# **Perth Metropolitan Desalination Proposal – Water Quality Management, Change to Implementation Conditions**

**Section 46 Report and recommendations  
of the Environmental Protection Authority**

**Environmental Protection Authority  
Perth, Western Australia  
Report 1327  
May 2009**

Assessment No. 1570

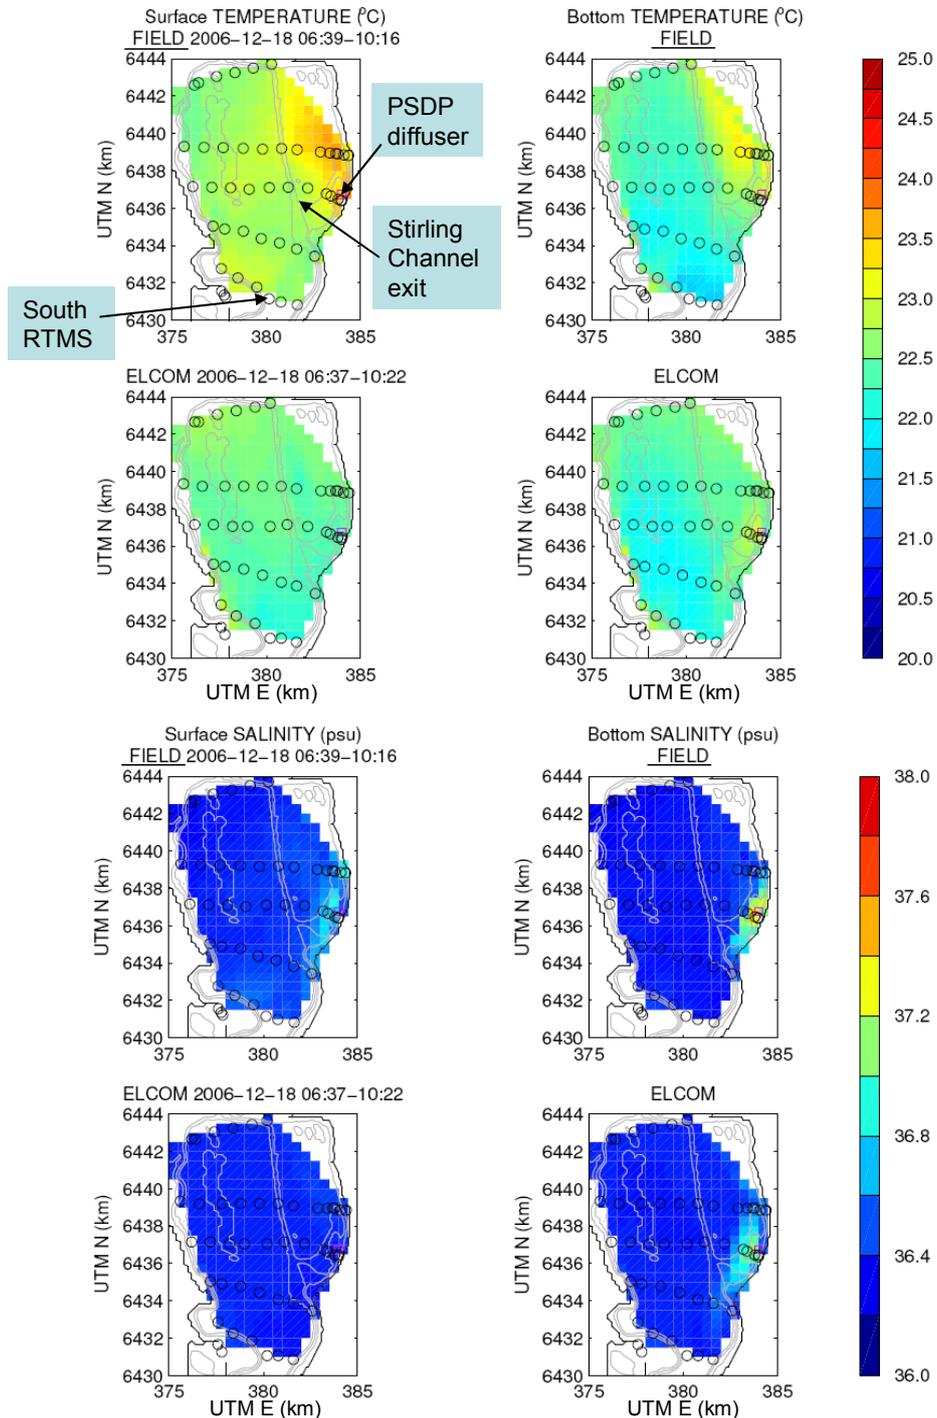
There also appears to be evidence both for and against plume influence in the basin-scale mappings of temperature and salinity. An example of no plume influence can be seen in the maps for 18 December 2006, 06:39-10:16, for temperature (Figure 4.13) and salinity (Figure 4.23) (both shown in Figure 15 of this report). These indicate stratification dominated by temperature, with no discernable effects of salinity. The corresponding dissolved oxygen maps (Figure 4.39, shown as Figure 16 in this report) indicate oxygen depletion in bottom waters and provide a good picture of the north – south gradient in oxygen demand mentioned in Section 3, with more severe depletion in the south. In contrast, the maps for temperature (Figure 3.5) and salinity (Figure 3.6) for 25 April 2007 (both shown in Figure 17 of this report) provide an example of what seems to me to be salt spreading from the exit of the Stirling Channel into the main basin, but with very little difference in temperature between surface and bottom. (No corresponding basin-scale maps for dissolved oxygen are given for this date.)
